Our Ref: 15131

26 June 2015

**Re: State Significant Development (SSD 6766) - SIMTA Intermodal Stage 1 at Moorebank**

**Figure 1 – extract of Table 1-3 from Noise Assessment**

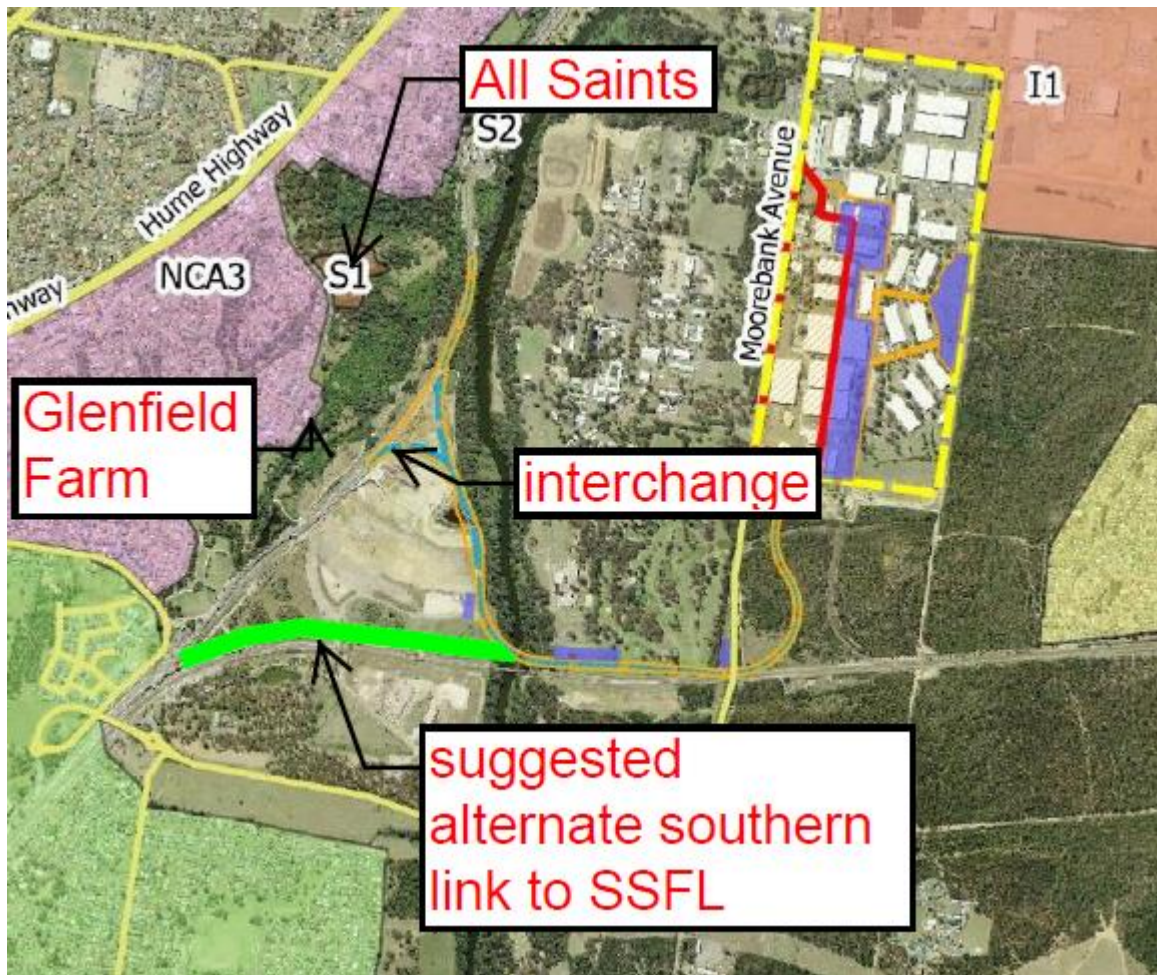
There appears to be scope to provide the southern access in a manner that will have far less impact than is currently proposed. In this regard as indicated on **Figure 1**, the access could simply follow the alignment of the existing East Hills Line and join into the northern link. This would remove the sharp curve which will significantly exacerbate already unreasonable noise impacts. It would also have other environmental benefits.
